**Re: GE-Pittsfield/Housatonic River Site  
Rest of River (GECD850)  
Dispute Resolution on Certain Conditions and Directives in EPA's "Conditional  
Approval" Letter for GE's Corrective Measures Study Proposal**

**GENERAL ELECTRIC'S STATEMENT OF POSITION ON  
OBJECTIONS TO CERTAIN CONDITIONS AND DIRECTIVES IN  
EPA'S CONDITIONAL APPROVAL OF  
GE'S CORRECTIVE MEASURES STUDY PROPOSAL**

**Figure 1. Comparisons of lipid content and PCB concentrations of largemouth bass fillet and offal samples from the 1998 EPA and 2002 GE sampling programs.**

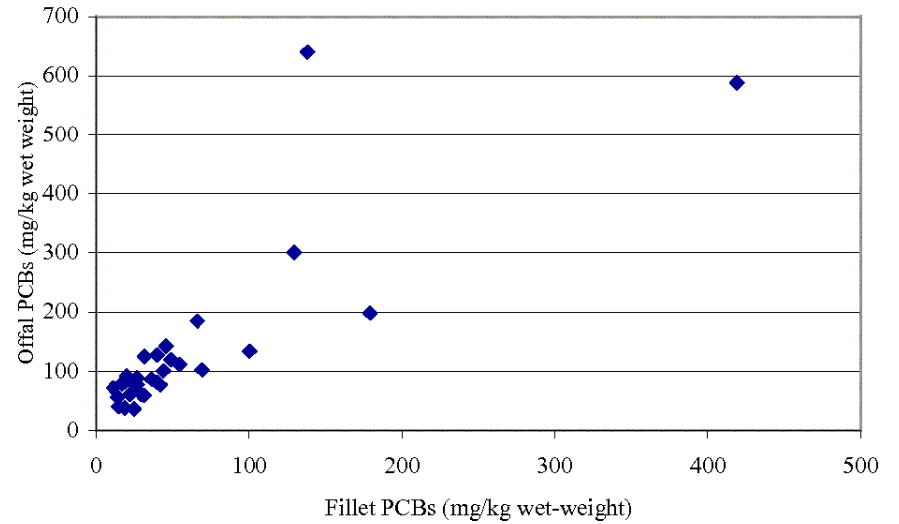
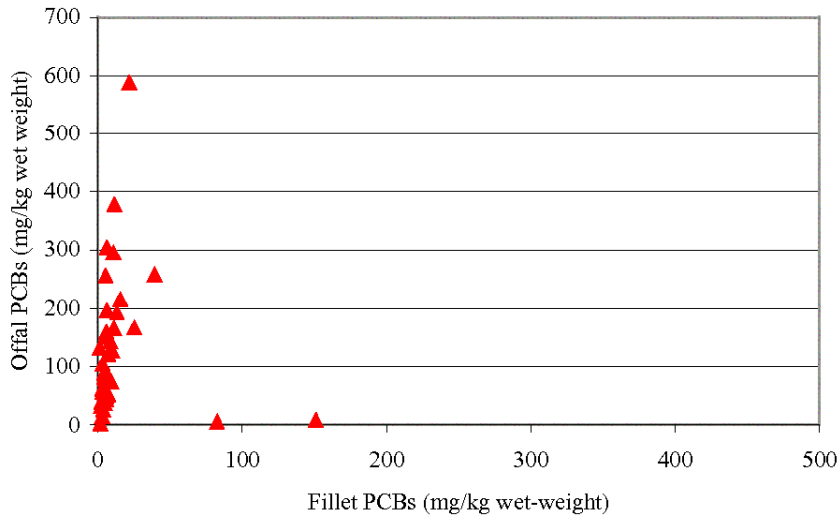
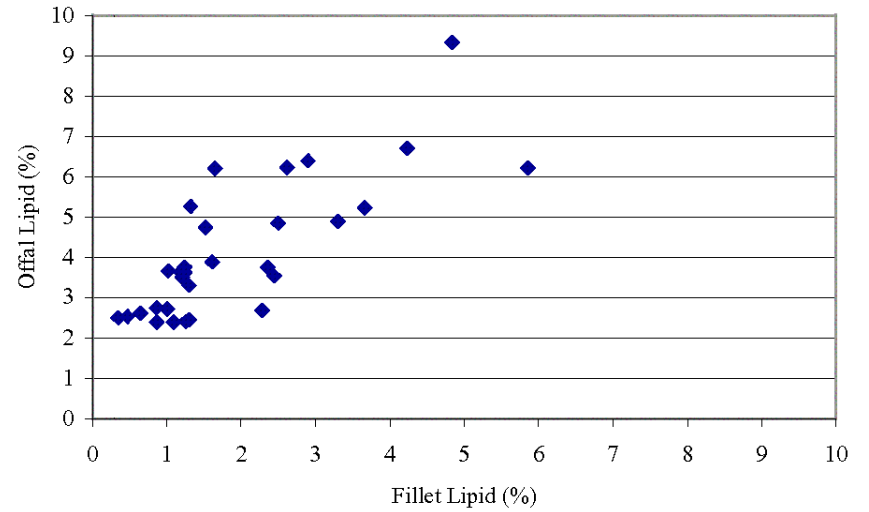
This EPA directive is unjustified for a number of reasons. First, it was reasonable for GE to exclude the EPA dataset from its calculation of a conversion factor. As previously discussed in the EPA-approved *RCRA Facility Investigation Report* (RFI Report) (BBL and QEA, 2003, Appendix D, Section D.3), the EPA dataset contains a number of fillet samples with extremely low lipid levels – in some cases, lower than can reasonably be expected based on fish physiology. Since the accumulation of PCBs in fish tissue is highly dependent on the lipid content of the fish (i.e., fatter fish have higher PCBs), the low fillet lipid levels in the EPA dataset led to lower reported PCB concentrations in the fillets. In fact, the RFI Report noted that the wet-weight PCB concentrations in fillets in the 1998 EPA dataset for Reaches 5 and 6 were 2.5 to 10 times lower than those in the 2002 GE dataset.

While EPA stated that its analysis excluded a small number of data points with questionable lipid results, the fillet lipid values in the overall EPA dataset appear to be anomalously low. This is indicated by a comparison of the fillet data with the offal and whole-body data in the two datasets. In the offal samples and the reconstructed whole-body data for the fish from Reaches 5 and 6, both the lipid contents and the PCB concentrations were very similar between the EPA and GE data sets. It was only in the fillets that the lipid levels and PCB concentrations were disparate – i.e., far lower in the EPA dataset. Moreover, the EPA data do not show a proportional relationship between the lipid levels in the fillets and those in the offal, unlike the GE data, which do show such a relationship (see Figure 1, top panel). The same is true for the wet-weight PCB concentrations in the two datasets (see Figure 1, bottom panel). These comparisons indicate that the low lipid values in the EPA dataset are suspect and may be a sampling artifact. This creates considerable uncertainty in calculating whole-body to fillet ratios from the combined EPA-GE dataset. If the PCB concentrations in the EPA fillet samples are biased low due to unrealistically low lipid contents, then the resulting whole-body to fillet PCB ratio will be biased high. In these circumstances, it was appropriate to rely on the values in the GE dataset in calculating a whole-body to fillet conversion factor.

In addition, because of the low lipid values in the EPA dataset, the ratios of whole-body to fillet concentrations in the combined EPA-GE dataset are so variable and uncertain that they cannot support selecting any particular ratio from the range of values in the combined dataset as “representative.”<sup>2</sup> As a result, it was arbitrary for EPA to simply select a ratio of 5:1 from that dataset and call it “representative.”
